**From:** Sue MacIntyre [mailto:████████████████████]  
**Sent:** 09 February 2016 15:04  
**To:** Gracie, Ian  
**Subject:** Planning application 44 Murray Mews

**Comments on the proposed development of 44 Murray Mews, based on plans submitted to Camden Planning Department (Application ref. 2015/7138/P)**

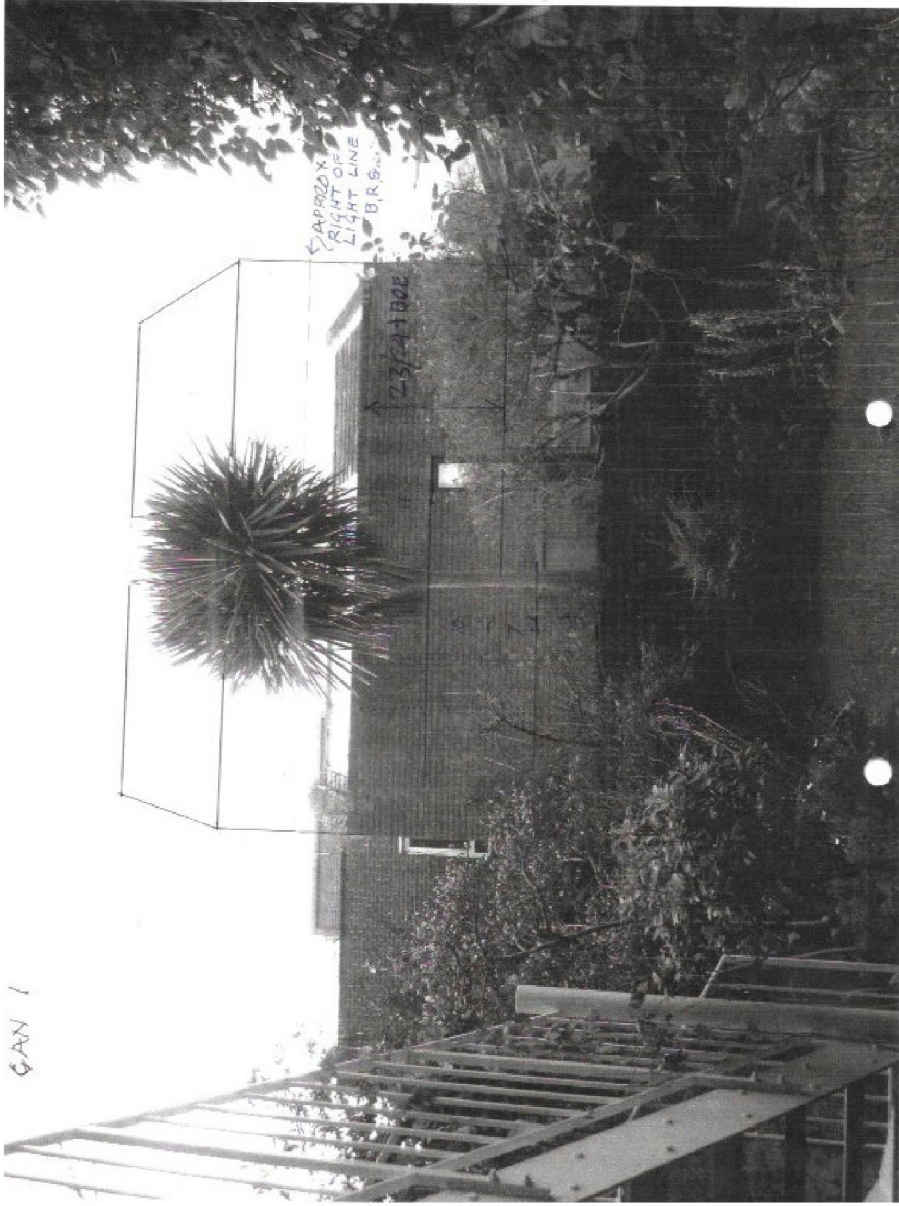
02 The site: the architect claims that the short street fronting elevation 'limits its presence on the street'. However this will not be the case if the proposed sheer front three story elevation is built.

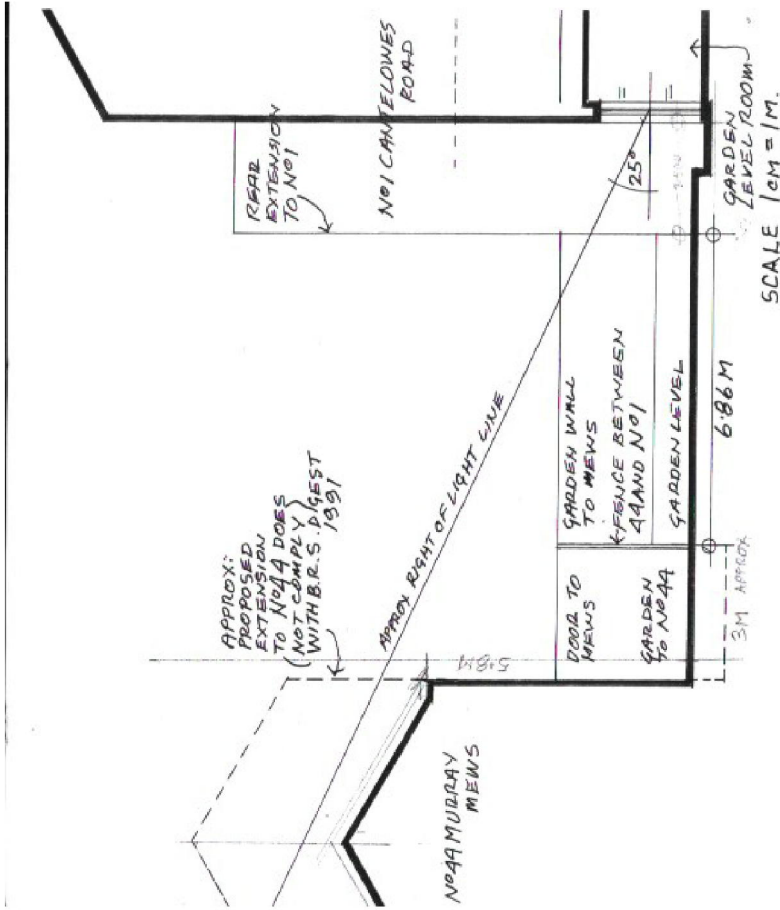
04 Precedent: The examples cited are not precedents for the present proposal in several respects:

No. 26 has a very discreet pitched roof second storey, hardly visible from the street, and we assume there are the lengths of two gardens between the property and St Augustines Road at the back, so there is not the same oppressive proximity to neighbouring buildings as we will experience if this development goes ahead. We are friends with the owner of No. 40 and have been in her house. The admittedly ugly third storey is very set back from the Mews frontage. Additionally the house is set back from the Mews by a front garden. At the back there are two gardens between it and St Augustines Road, so again the third storey does not cause problems of proximity for neighbouring houses. This house is the same height as the proposed height of 44 Murray Mews, as has been marked on the architect's drawings, but the distance between it and the houses at the back is much greater. The second storey of No. 43 Murray Mews is well set back from the Mews and there is also space for off-street car parking in front of the building.
